ELDORADO SPRINGS

STORM SEWER PLAN & PROFILES

ELDORADO SPRINGS	
STORM SEWER PLAN & PROFILES TITLE SHEET

Construction Drawings_v6 engr redlines.pdf Markup Summary

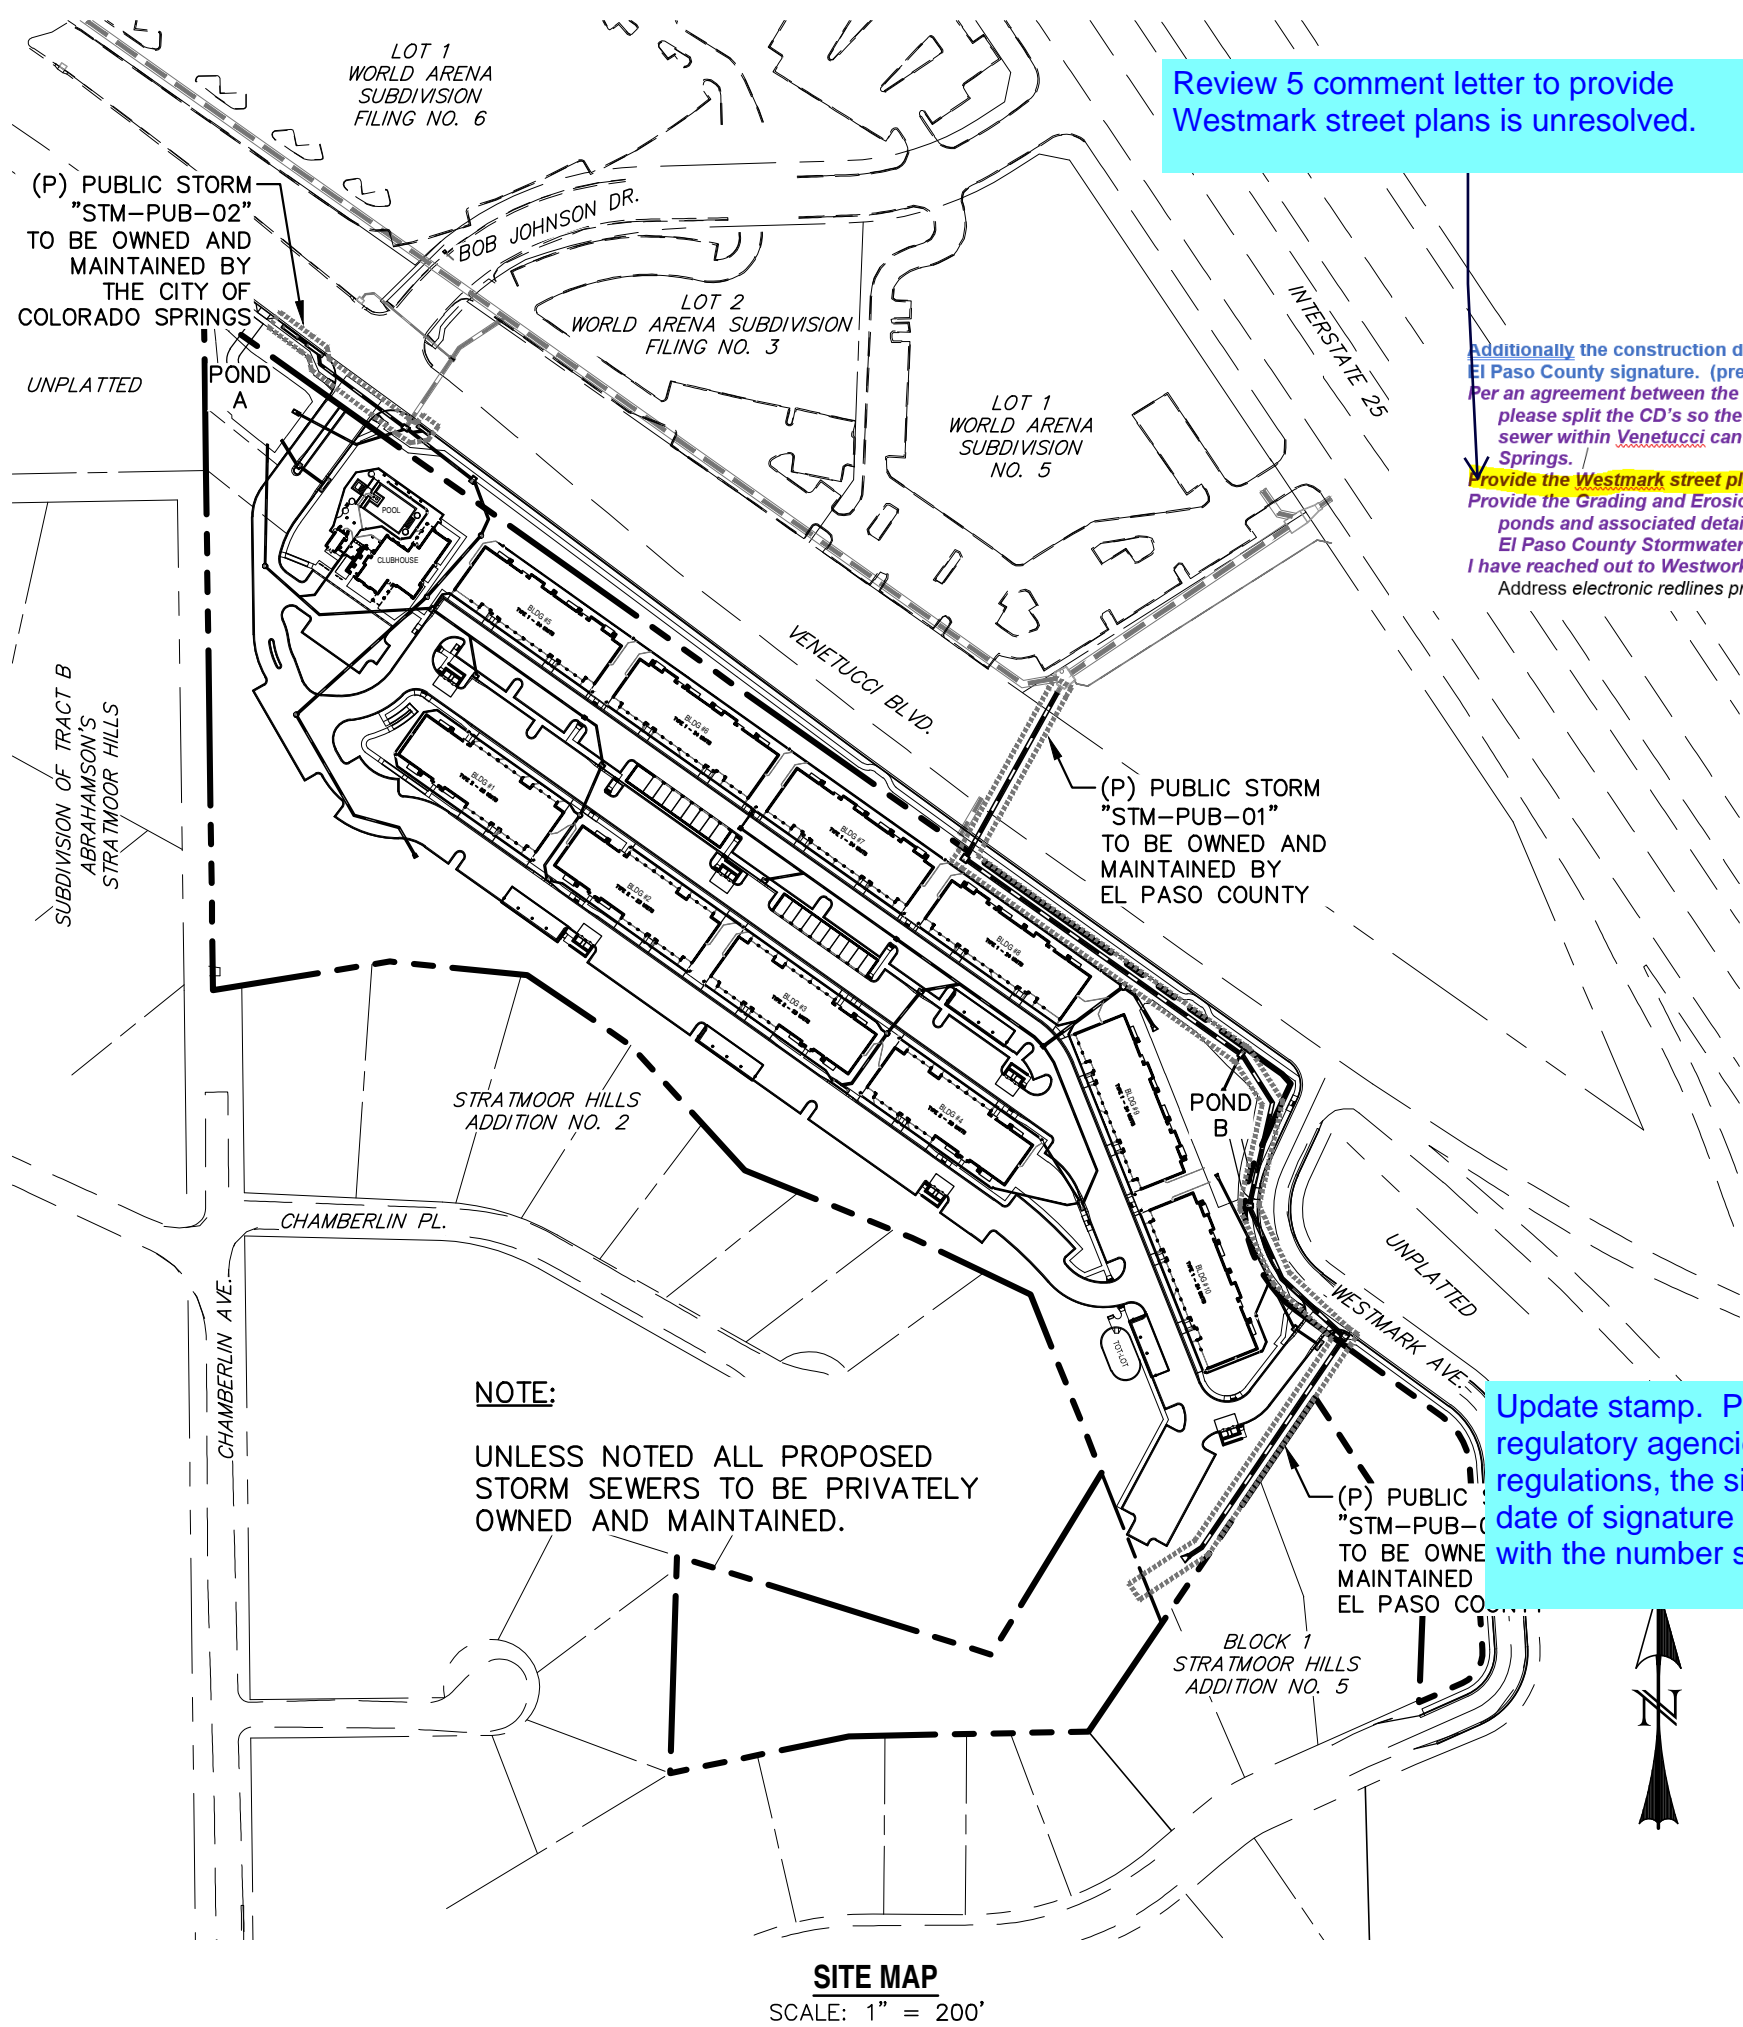
fill in the blank for
note 25

fill in the blank for
note 25

Add "PCD File No. PPR1932"

Add "PCD File No. PPR1932"

STORM SEWER PLAN & PROFILES
STM-01, STM-02, STM-03, & STM-03A

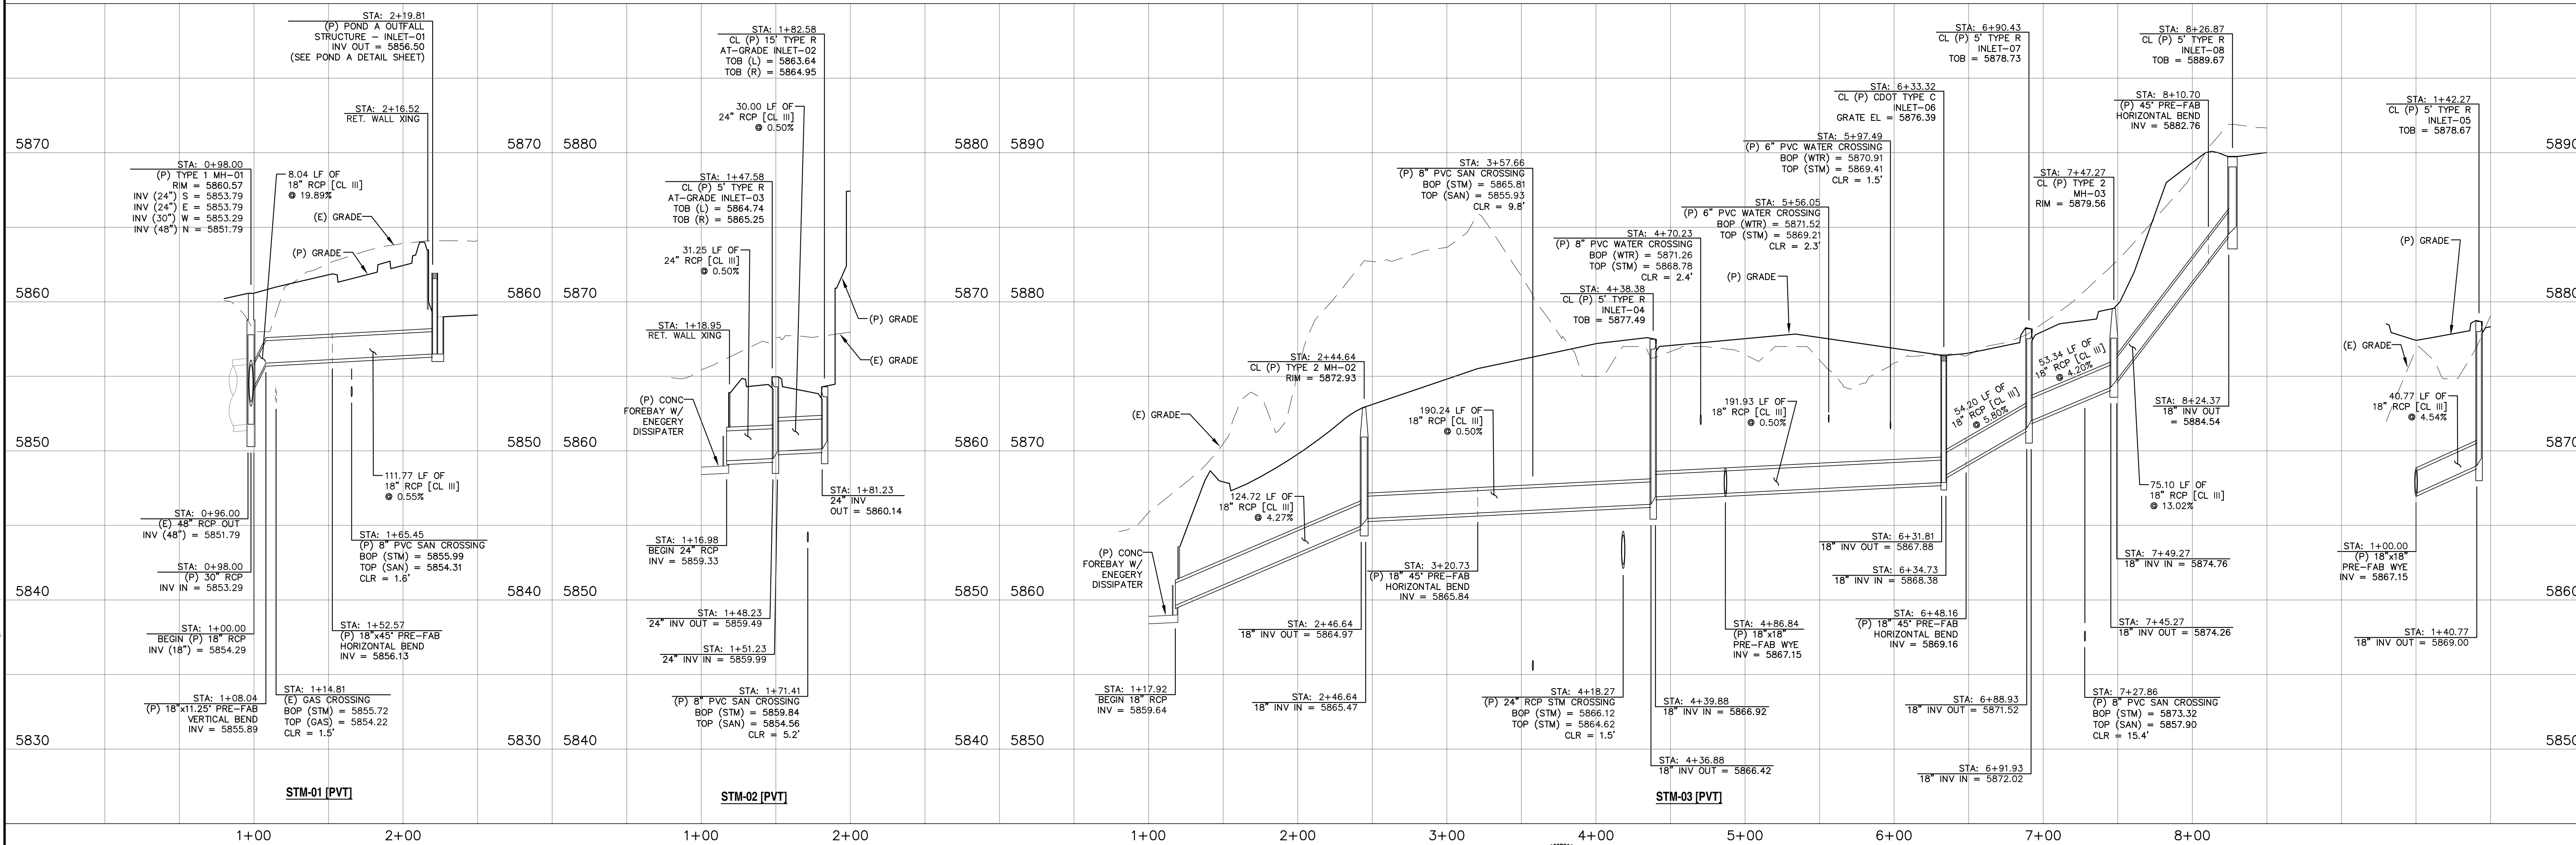
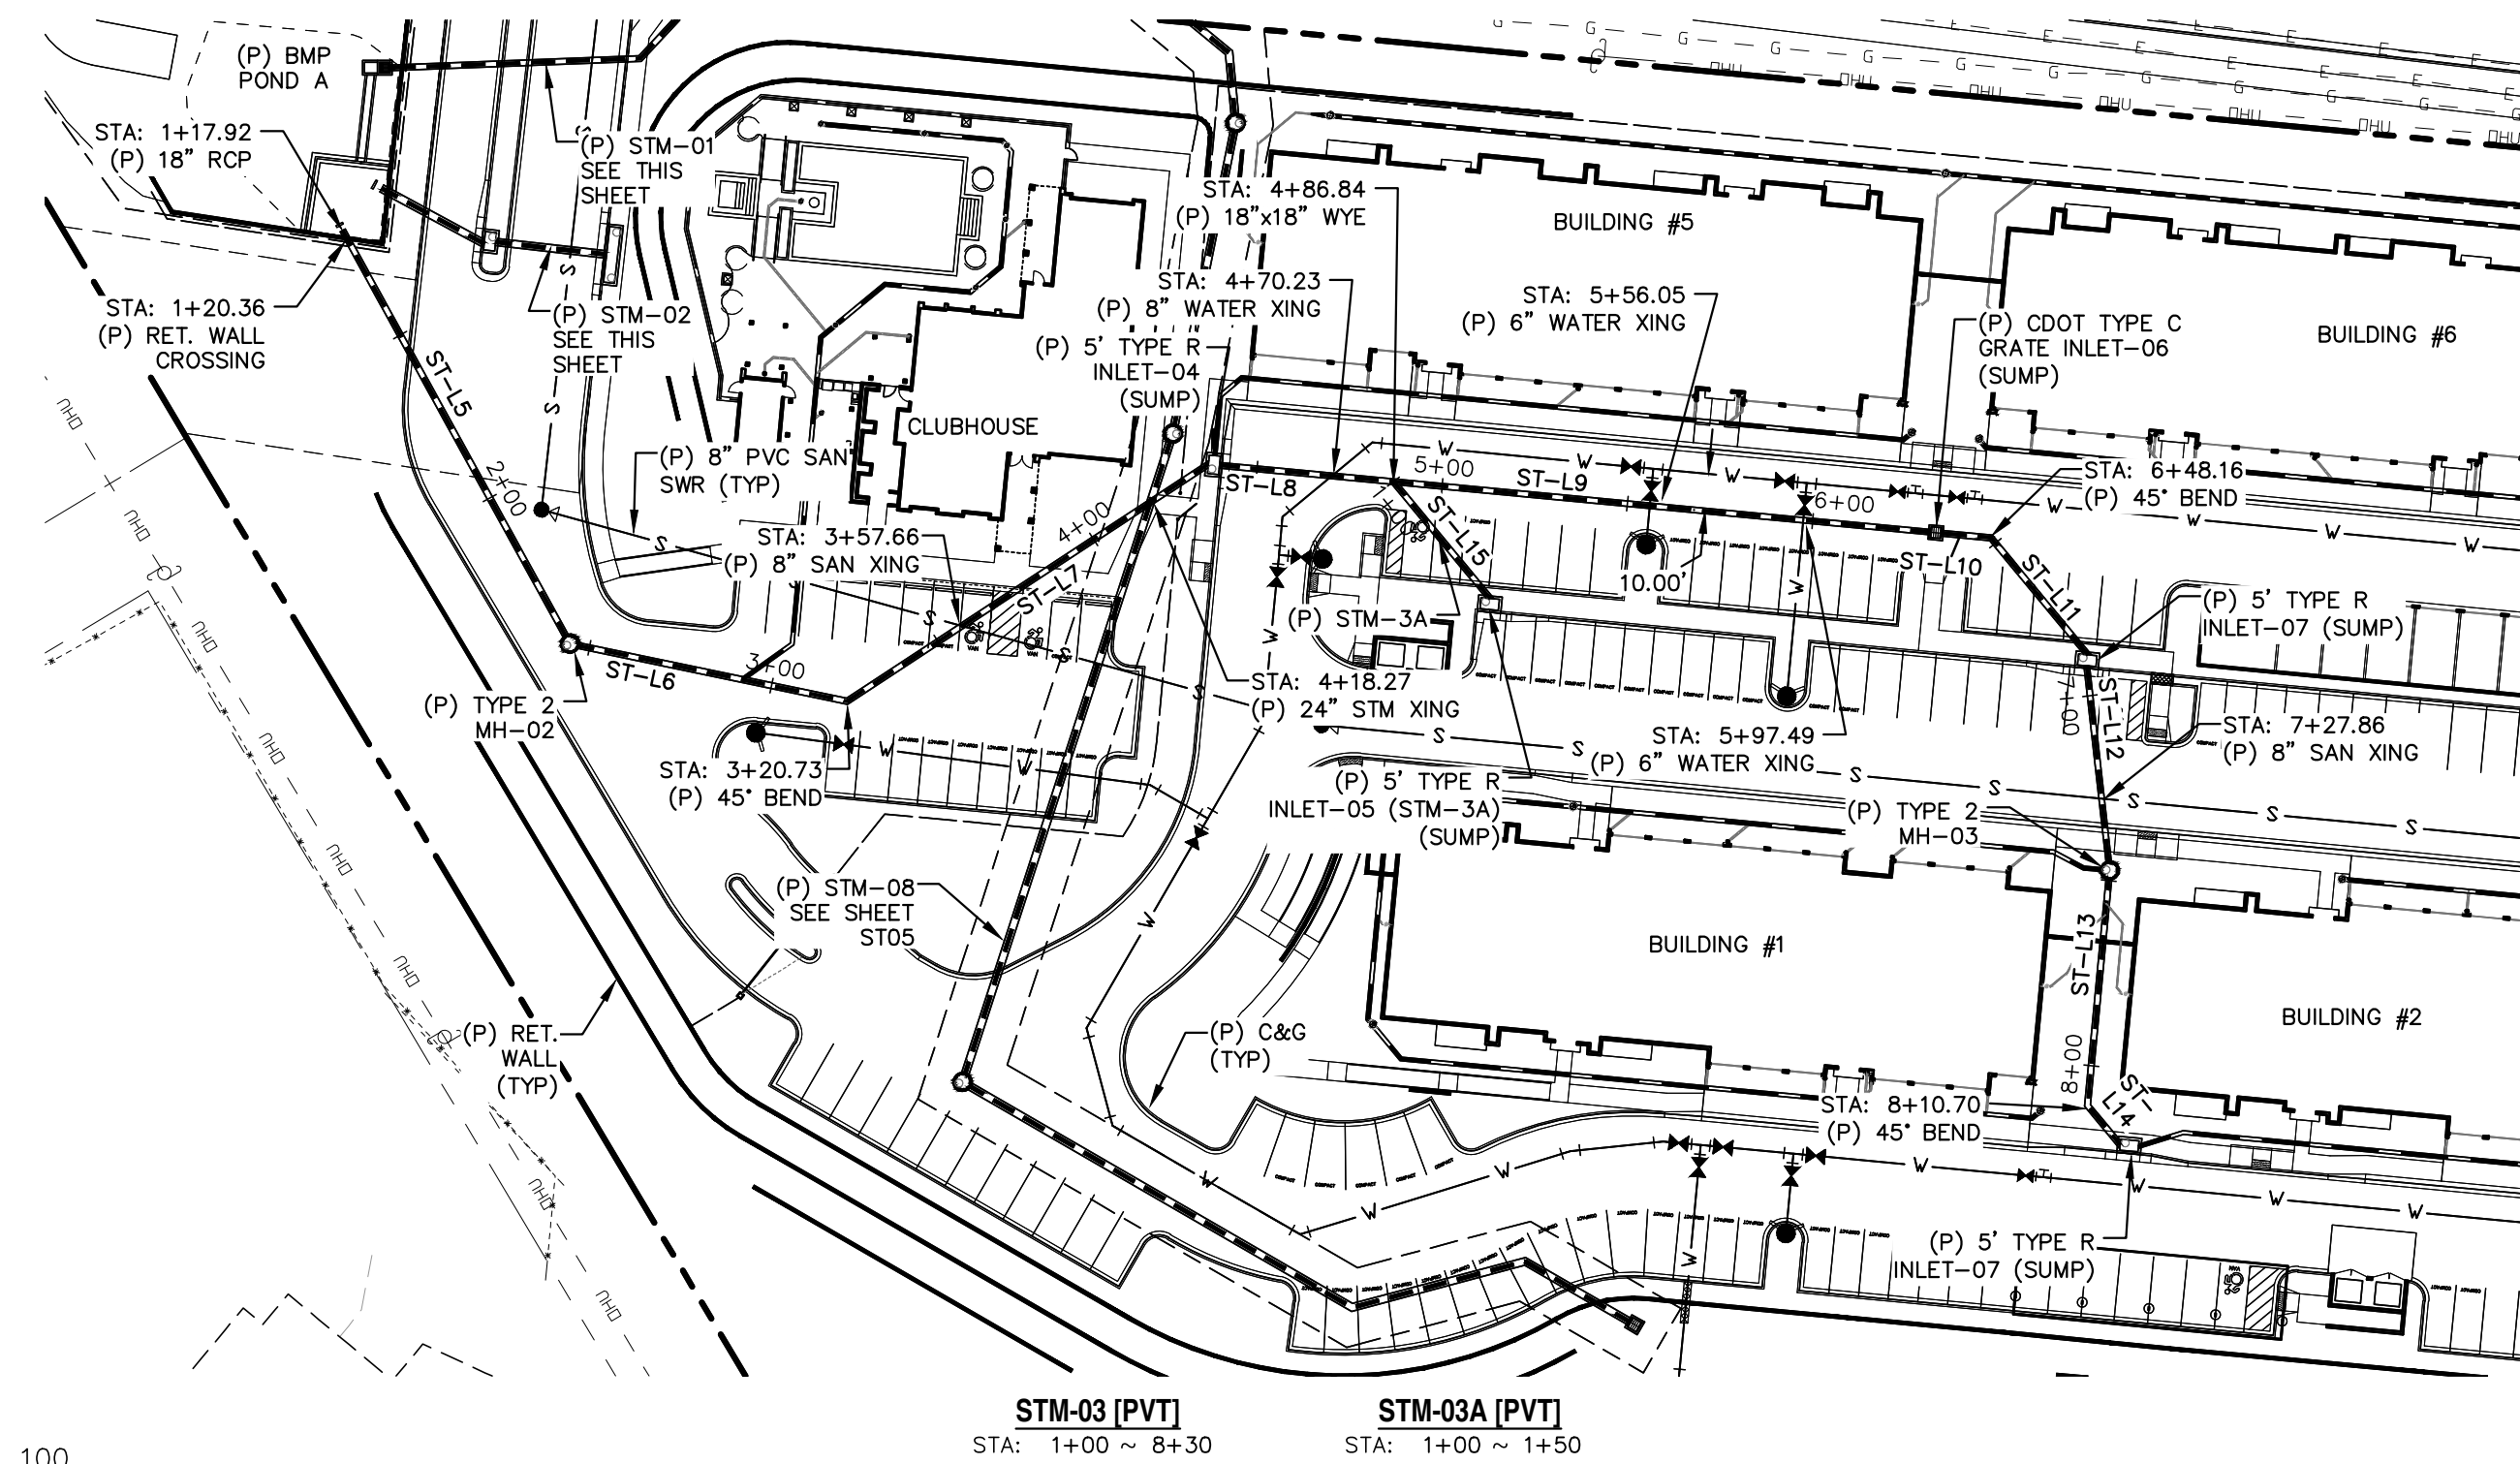
Per the review 5 comment letter, Public STM-02 is approved through the City. Add a note referencing the specific approved City construction plan and note what's shown on this plan is for reference only.
